N4693D-02

Modification Recommended Service Note

N4693D Electronic Calibration Module (ECal)

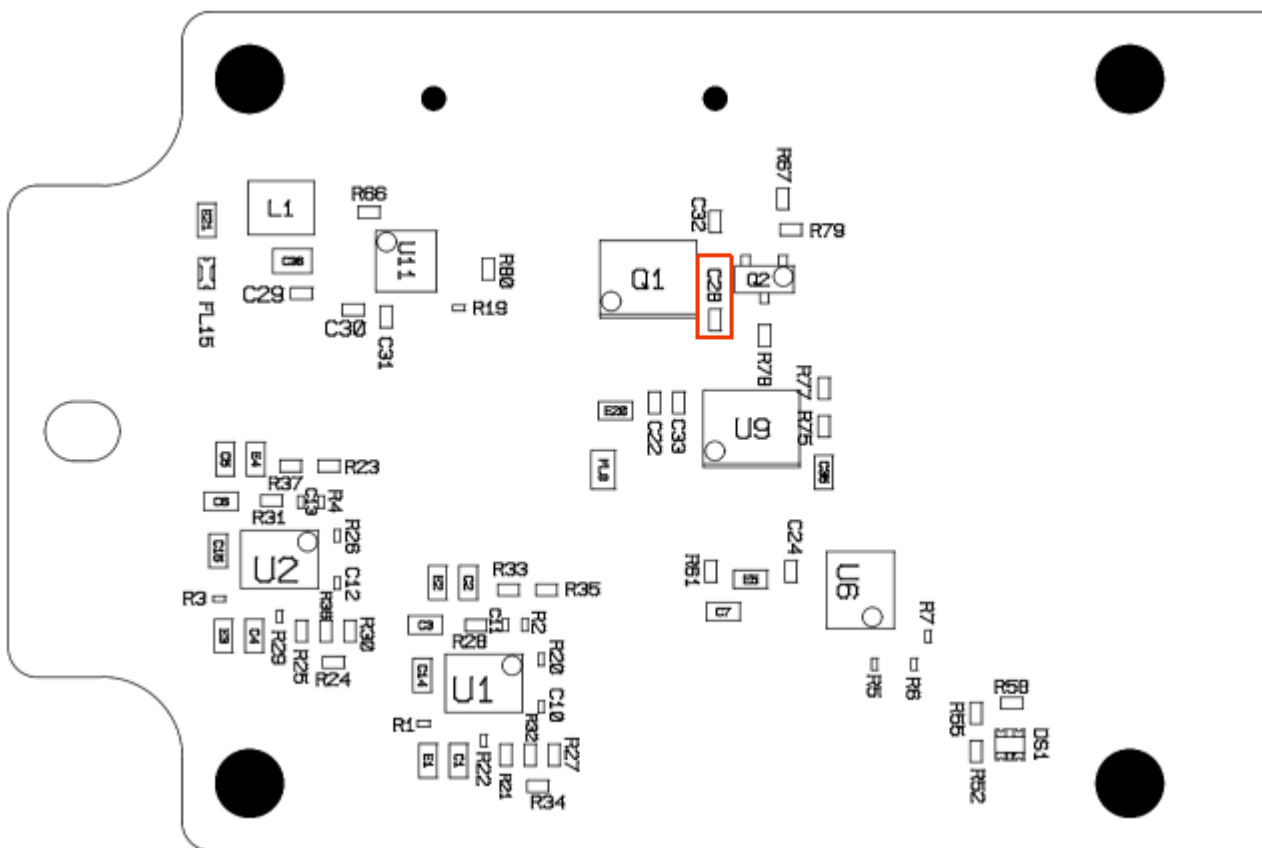
The heater circuit in the N469xD ECal modules was initially designed with a dampening capacitor. It was found in a small number of ECal modules that a resonance can develop in this circuit after the modules is warmed up. This resonance can cause an RF tone between 140 MHz and 150 MHz to be injected onto the signal path.

The dampening capacitor was eliminated in all ECal modules with serial prefix MY5941 and above.

Open the ECal module and remove the N4690-63004 printed circuit board. On this board, locate the C28 capacitor indicated here:

If this capacitor has been removed, no further action is required. Reassemble the ECal module.

If this capacitor exists on this board, this capacitor should be carefully unsoldered and removed, or the N4690-63004 printed circuit assembly should be replaced. Once this is done, reassemble the ECal module.
